Crown Pastoral Land Tenure Review

Lease name: Allandale / Greenvale

Final Report on Public Submissions

FINAL ANALYSIS OF PUBLIC SUBMISSIONS
ON PRELIMINARY PROPOSAL
ALLANDALE AND GREENVALE PASTORAL LEASES

Figure 2. Public access routes to proposed conservation land in Roberts Creek (red), showing proposed Conservation area (edged pink) and proposed freehold (edged green). Conservation management access is proposed along track c-d, and farm access along d-f.

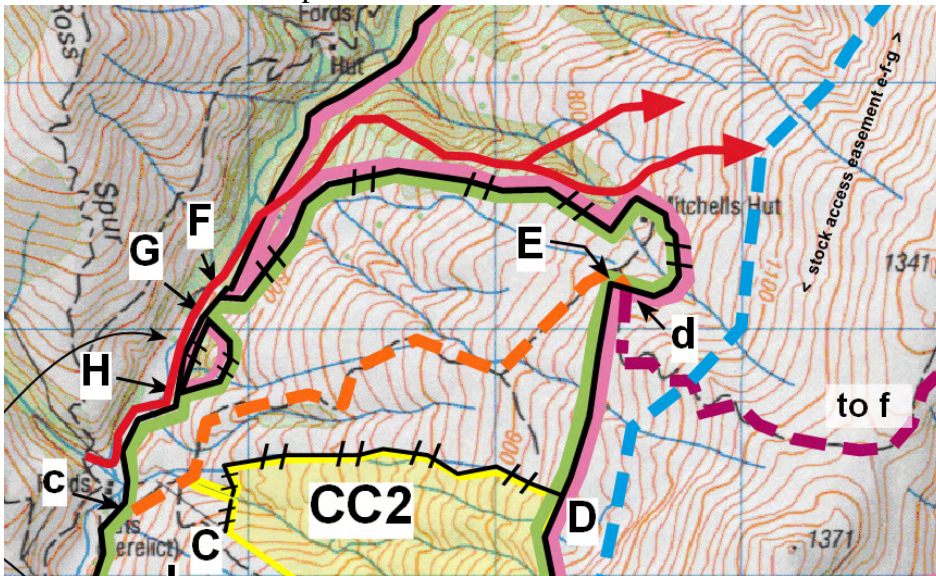
Submitters 5 and 8 suggested that public access should be provided up the same route except that they suggest it should go to Mitchells hut near point 'F'. These submitters suggested that accessing the new conservation land from Robert Creek would otherwise be a difficult proposition. Submitter 8 suggested a foot access easement, and it appeared that submitter 5 was also not necessarily proposing public motorised vehicle access.

The whole issue of public access to the proposed conservation land up the Roberts Creek valley was reviewed. The use of the track indicated was considered to be unattractive from a public use perspective, since it traverses through highly modified farm country, would inevitably require track closures related to farm activity, and would be likely to result in ongoing tensions between the farming activity and public use. The track was also not seen as being of a sufficient standard to warrant general 4 wheel drive public access, and to upgrade it and maintain it for such use would not be warranted. Good alternative public foot access was identified using Roberts Creek riverbed

and marginal strip, then passing directly into the conservation land. Once in the conservation land, direct and practical access to the higher country is then available up the existing cleared fenceline which will become the conservation boundary. This situation is displayed in Figure 2. The point has therefore not been accepted.

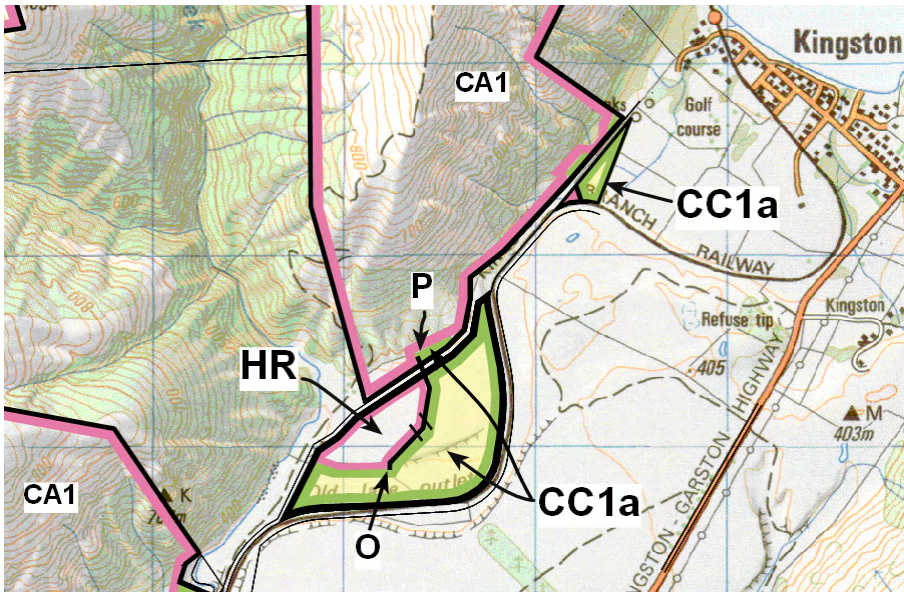
Submitter 8 stated that central part of CC1a had a good cover of short tussock with a dominance of native inter-tussock herbs, and also matagouri, and that these values may not be adequately protected if grazing was allowed to continue.

Submitter 12 noted that the central area of CC1a contained representative short tussock grassland, and that it was a land environment that is acutely or chronically threatened. They also considered that the area would be viewable at close quarters by the public, and that there was a need for public access through the area. This submitter believed that the area should be retained in the conservation area. The submitter argued that if light grazing was required for grassland restoration, this should be carried out under Department of Conservation management, where restoration could be the goal, rather than economic return.

This issue has required more review and consultation than any other point in submissions. The main upper terrace area has been confirmed to be classified as “acutely threatened” and the land below the terrace as “chronically threatened” at LENZ level IV. Indeed, the main LENZ unit (N3.1a) only has 2.9% of that unit still with indigenous vegetation nationally, and that percentage has been shown to be decreasing since 1997, and only 0.5% of the unit is protected. The area was ground inspected in detail and confirmed to have predominantly indigenous vegetation cover composed of hard tussock and shrublands. Gorse and exotic broom are beginning to become a threat to this area, and accidental fires from the Kingston Flyer railway line, which forms the eastern border, continue to compromise values along that margin. Given the LENZ classification, particularly the upper terrace, and the indigenous vegetation cover, the site achieves the highest level of significance in the Department of Conservation’s criteria for defining significant inherent values.

The appropriate tenure was considered. Full Crown ownership and control could be justified for this site, but there was great difficulty in achieving this over the whole area, since the area is an integral part of the lowland farm operation. Although not cultivated, the well drained rocky nature of the terrace makes it a valuable grazing site during wet periods. The possibility of multi-use via a covenant was explored, however the Holders expectations of being able to graze cattle conflicted with the conservation objectives of enabling restoration of the vegetation, including the regeneration of shrubland species. Ultimately it was determined that the issue could not be resolved through a multi-use covenant, and the matter was resolved through a split of the area into land to be retained by the Crown for conservation as historic reserve, and land to be freeholded unrestricted by any requirement to manage the grazing of the site for vegetation restoration. The solution arrived at will see the Crown retention of the acutely threatened land that adjoins other land that is already reserve or proposed Conservation area. An added benefit of this solution will be that the area of Crown retention will encompass the sites of historic and archaeological value on this terrace. This solution also makes a practical boundary for the land being freeholded, where landform and landscape protection will still be provided by covenant CC1a.

The proposed outcome will ensure the protection of some of this area. The Department of Conservation consider that the area being retained is of sufficient size to be viable in the long term. However, protection is not being proposed over the entire terrace as suggested by some submitters. The point has therefore been accepted in part.
